CITY OF ALBUQUERQUE

RE: **9841 Buckeye St. NW**
Grading Plan
Engineer's Stamp Date 11/20/17
Hydrology File: B13D028

**9841 BUCKEYE STREET, NW
GRADING PLAN**

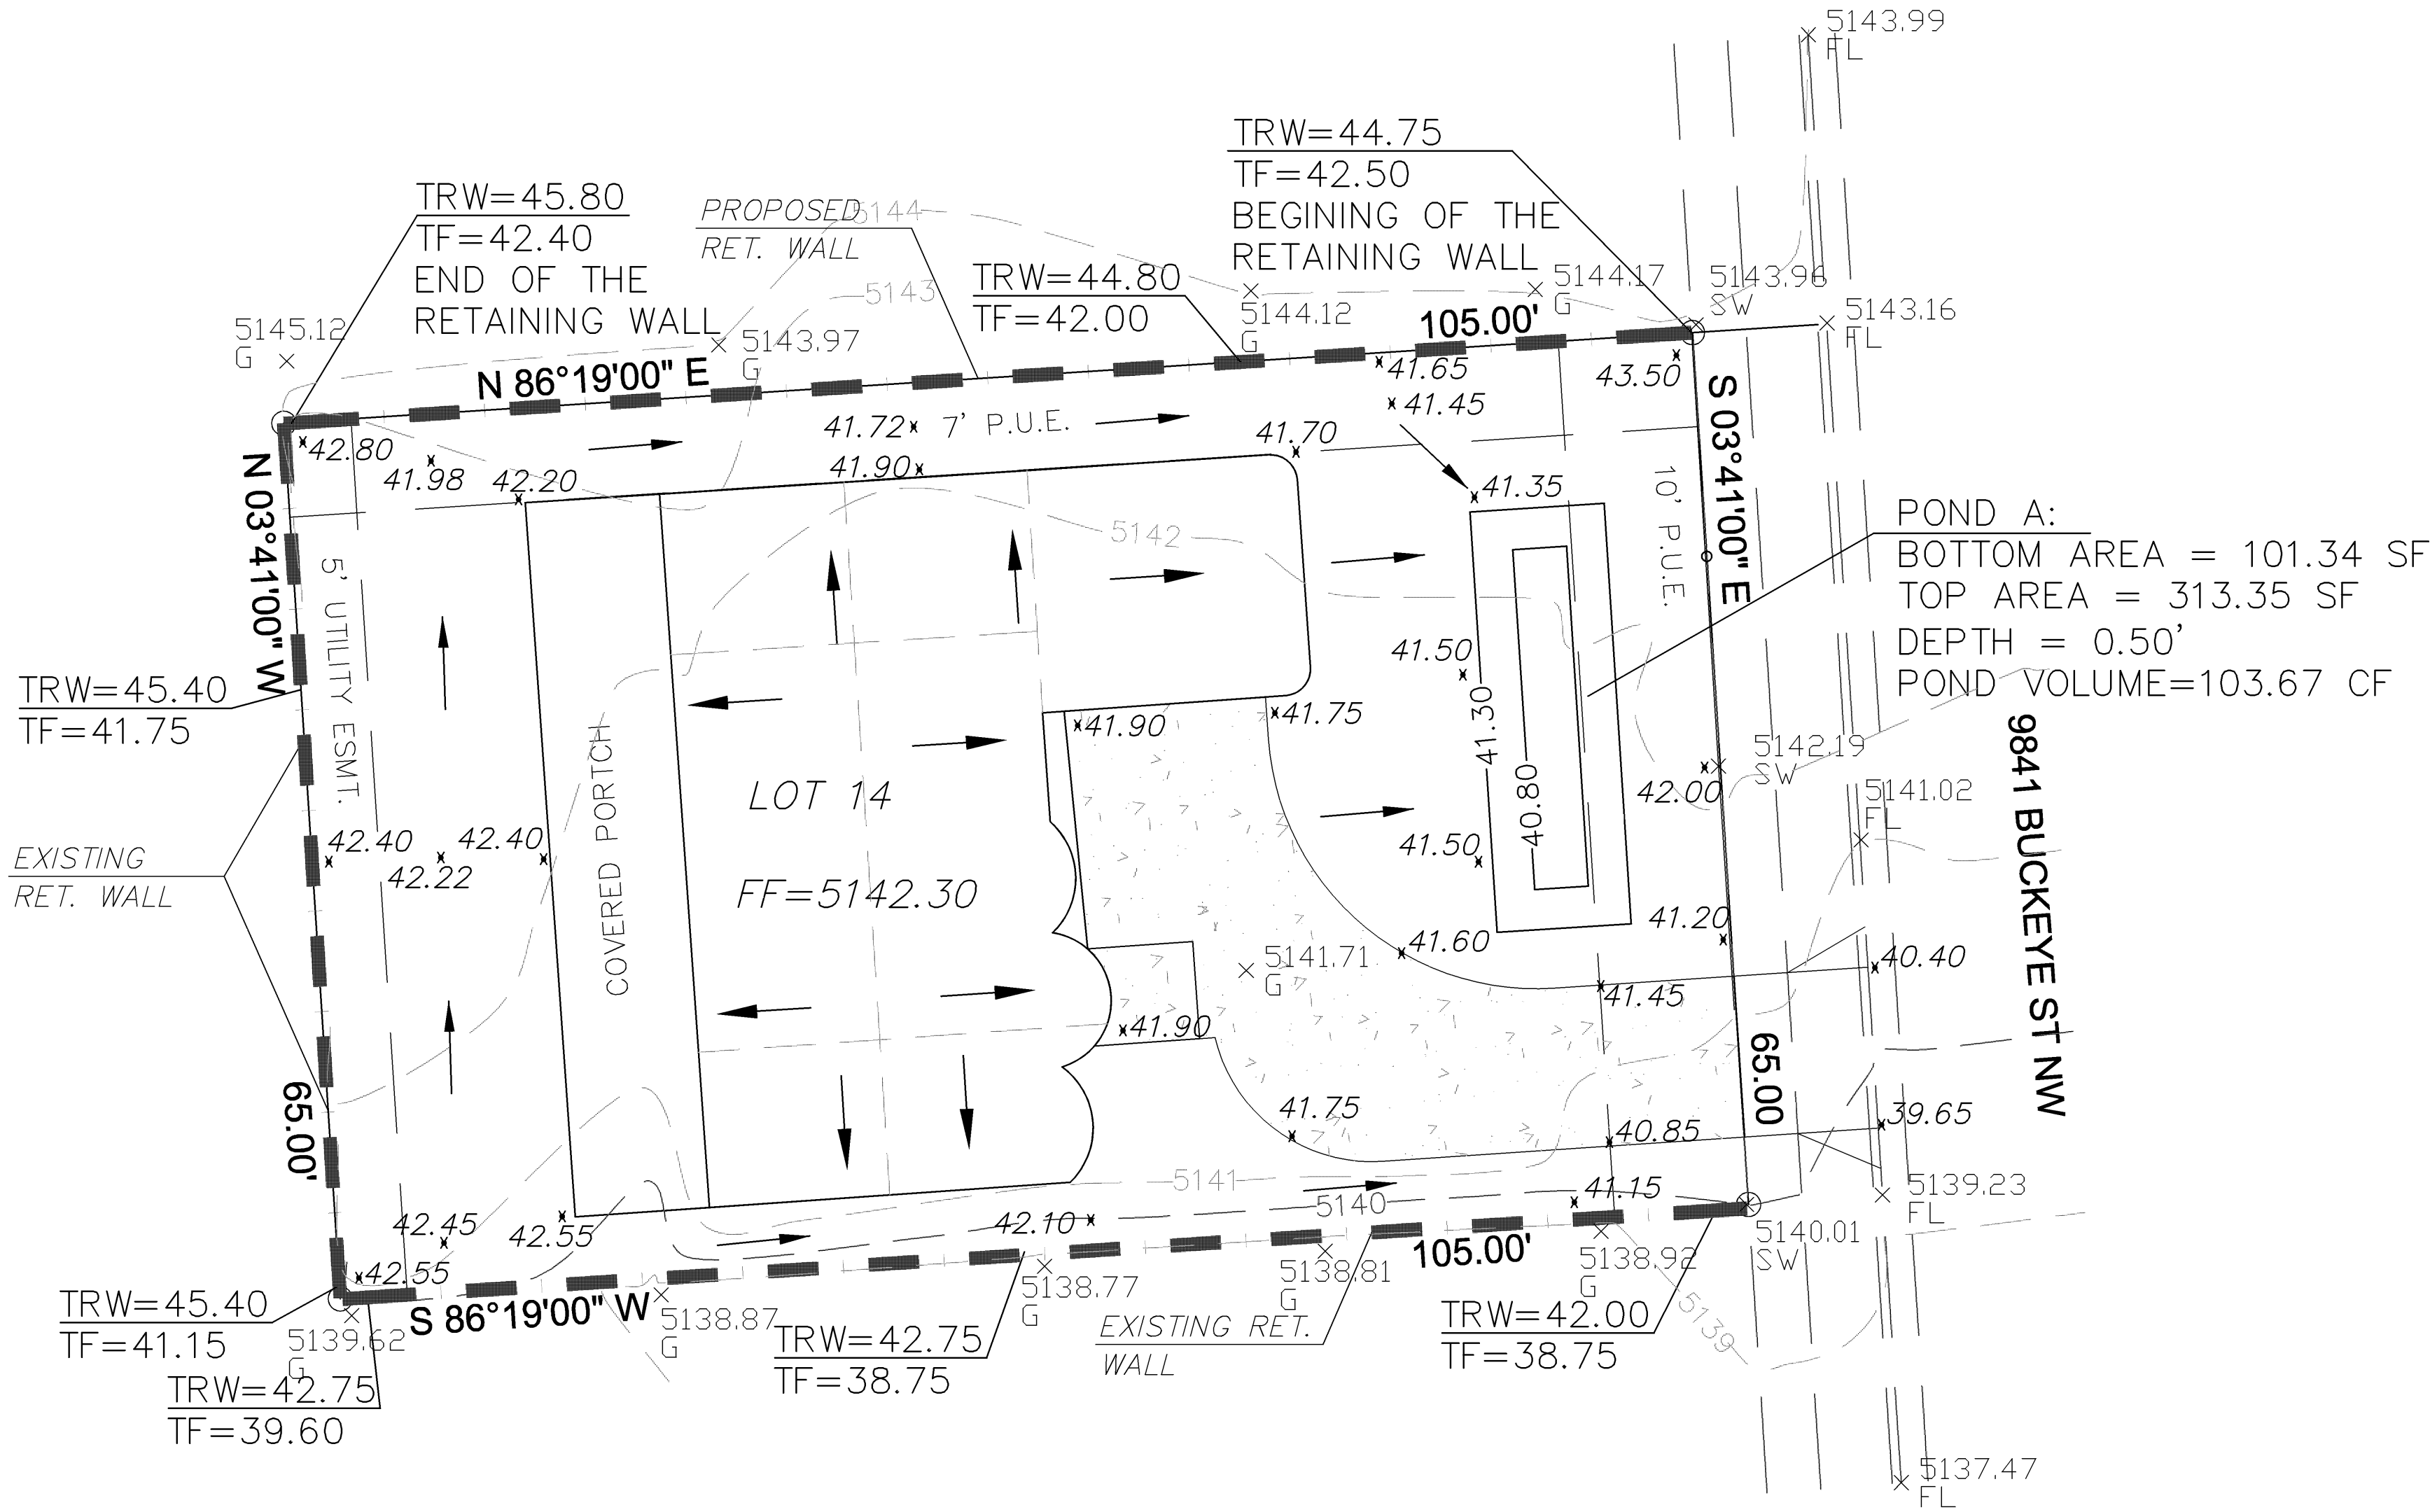
1. Provide section cuts of the proposed retaining wall and the two existing retaining walls. Ensure these section views show that the flowline is not set against any retaining walls or walls of the house.
2. Show the property line, existing and proposed grades on the section views. In accordance with Ch.22, section 5 part B, of the DPM, grading and wall construction near the property line may not endanger adjacent property or constrain its use.
3. If the proposed retaining wall will create such an encroachment, written agreement from both landowners must be provided for such work.
